SUBSURFACE WASTEWATER DISPOSAL SYSTEM APPLICATION

Town Or Plantation	AUGUSTA
Street Subdivision Lot #	347 LEIGHTON ROAD

GOODWILL INDUSTRIES OF ME
Last: First:

RE: Design flow of proposed Goodwill Industries facility, Leighton Road, Augusta.

SITE PLAN

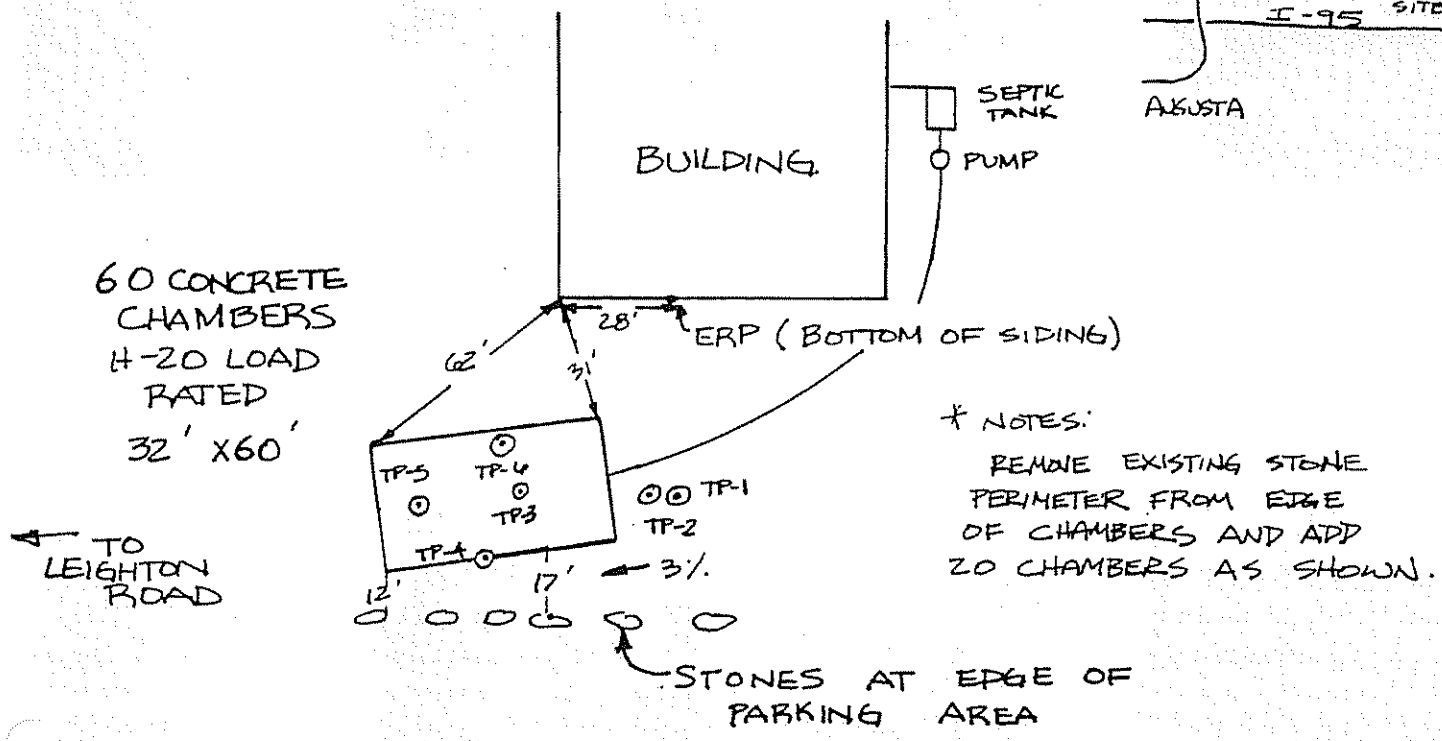
* NOTES:
REMOVE EXISTING STONE PERIMETER FROM EDGE OF CHAMBERS AND ADD 20 CHAMBERS AS SHOWN.

REVISED 3-29-94 (ADDED CHAMBERS)

SUBSURFACE WASTEWATER DISPOSAL PLAN

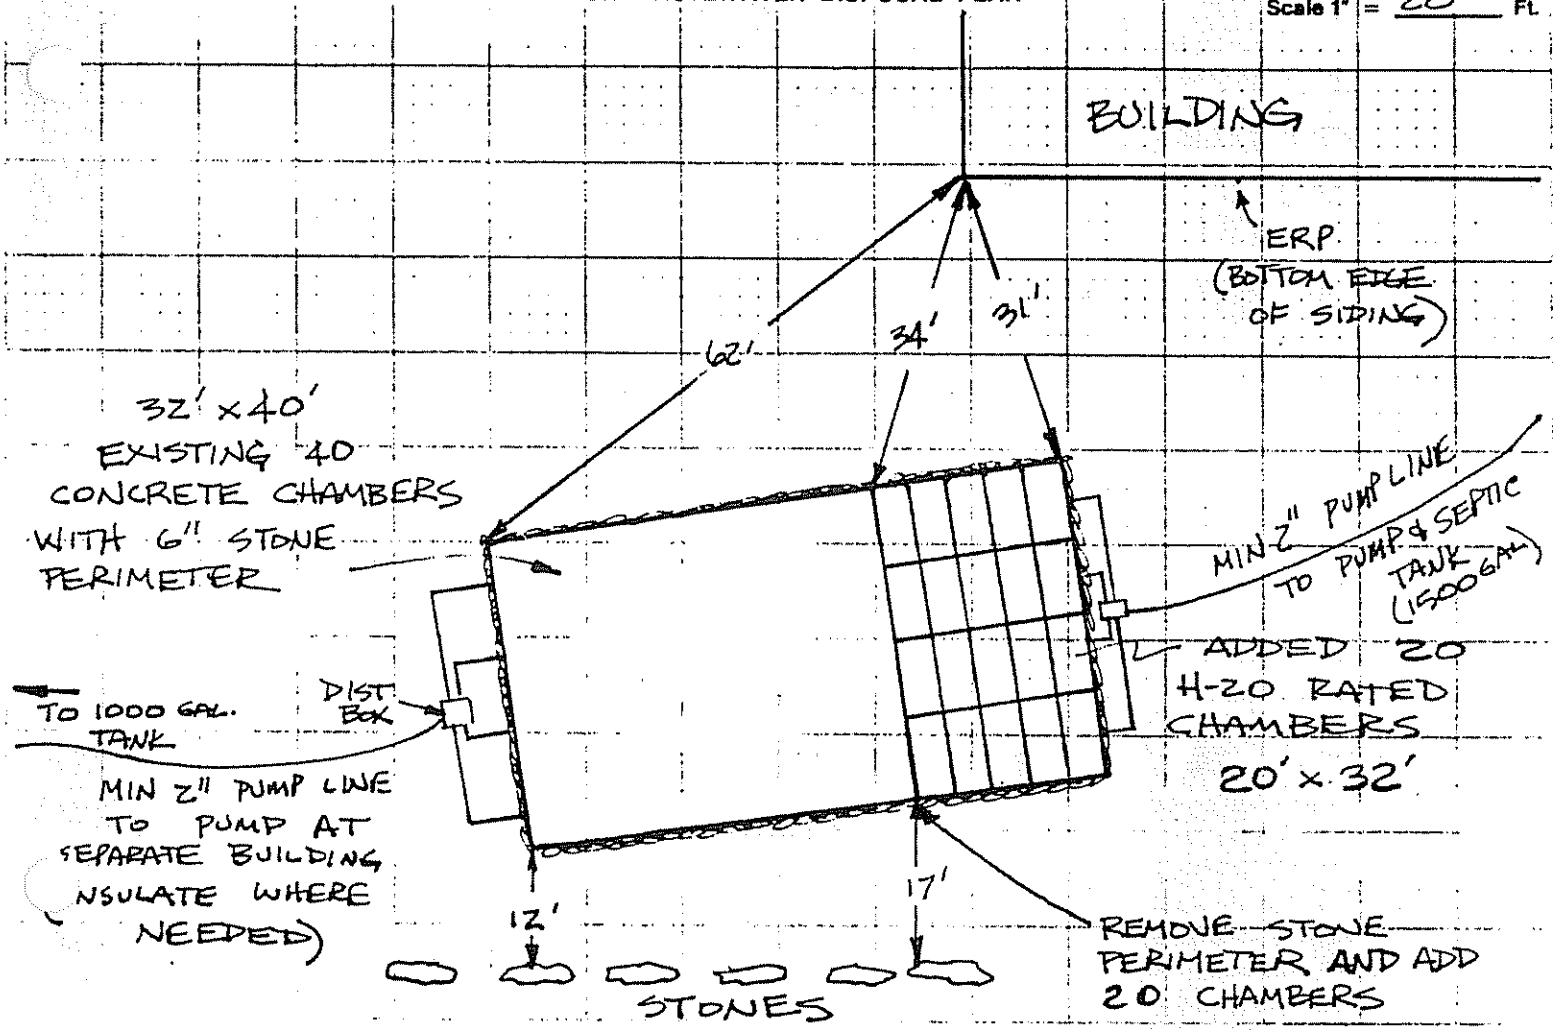
It seems to me the installed system should be expanded. If twenty H-20 load rated chambers were added to the existing 40 chambers, as shown on the accompanying design, the design flow would be 768 gpd. This enlarged system will be more appropriate for the proposed use of the building.
